Work Order ID 150125***150125***

Item Name: Gusset

APICAL INDUSTRIES, INC.	ENGINEERING CHANGE NOTICE NO. 03702				SHEET 1 OF 2	
	DWG NO. 646.3700	REV: A	PREPARED BY B. PETERS	DATE: 11/15/12	EFFECT ON DWG ☐ INC. ☒ UNINC.	
	DWG TITLE: SHEETMETAL					
APPROVED BY:		ENGR <i>[Signature]</i>	MFG <i>[Signature]</i>	QC <i>[Signature]</i>	EFF: NEXT ORDER	
TRANSACTION CODES (TC): A-ADD C-CREATE R-REVISE D-DELETE		REASON: ADDED ALTERNATE MATERIAL AND REVISED REFERENCE DIMENSIONS				EOR: D-12-010

**SHEET 7, ZONE C4 IS:****SHEET 7, ZONE D1 IS:****SHEET 7, ZONE B7 IS:**

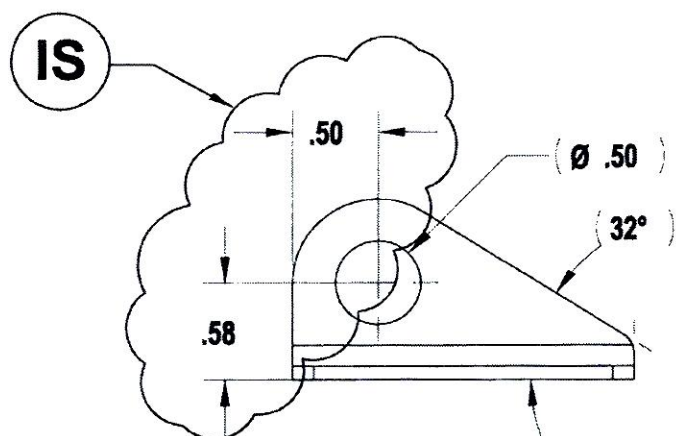
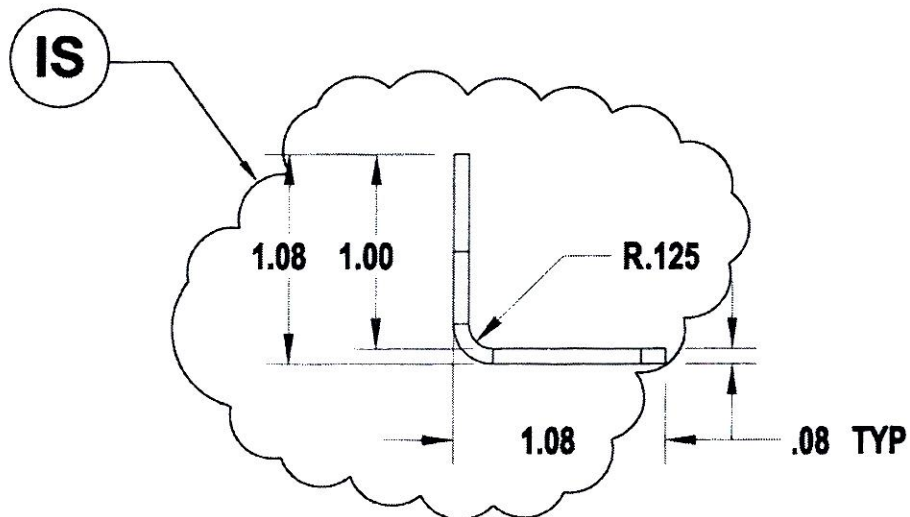
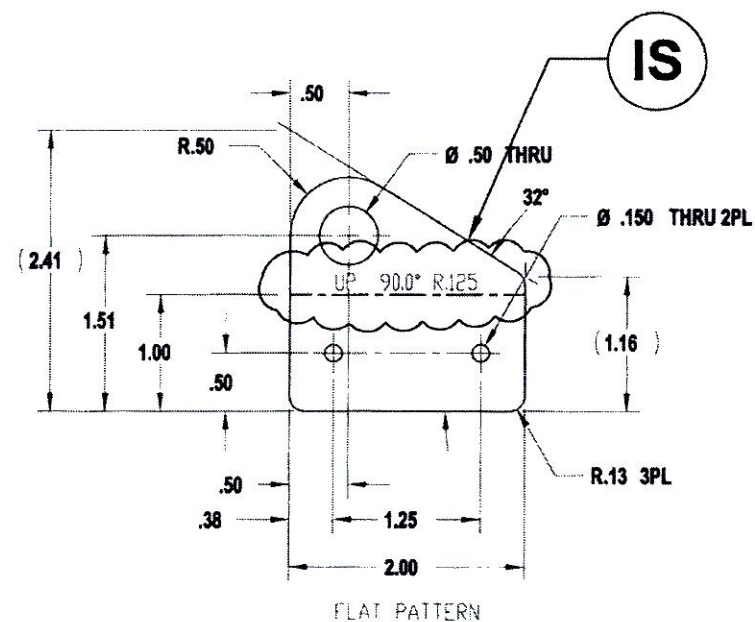
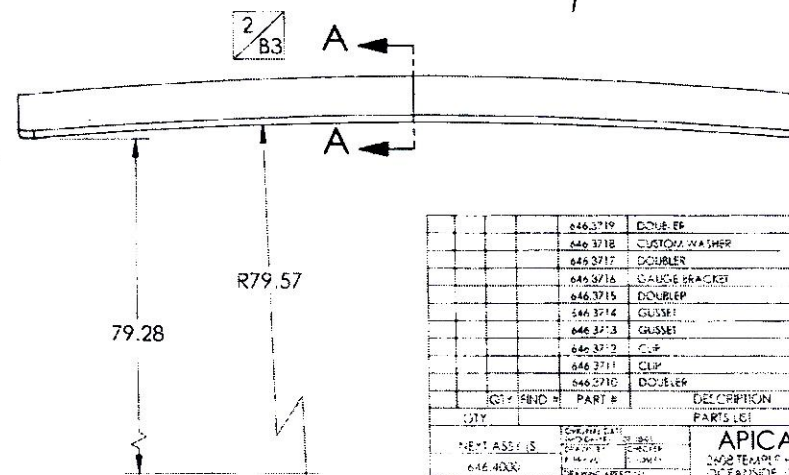
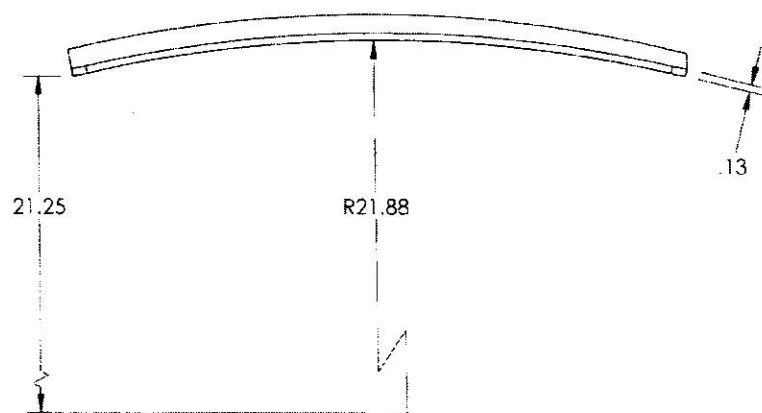
SHEET 1, ZONE A2 IS:

⚠ PRIMARY MATERIAL: ALUMINUM 6061-T6 PER AMS-QQ-A-250/11
ALTERNATE MATERIAL: SS 17-4 PH PER AMS 5604

SHEET 7, ZONE B1 IS:

1. MATERIAL: ALUMINUM 6061 T6 PER AMS-QQ-A-250/11
2. FINISH: HARD ANODIZE IAW MIL-A-8625 TYPE III
CLASS 2. COLOR BLACK:
CARDINAL 4860-50 PRETREATMENT PRIMER
PRIME IAW MIL-P-23377J TYPE I CLASS N
3. MATERIAL: 17-4 PH AMS 5604. CONDITION H900
4. FINISH: PRIME IAW MIL-P-23377J TYPE I CLASS N
5. DEBURR AND BREAK ALL SHARP EDGES
6. IDENTIFY IAW MPP-120
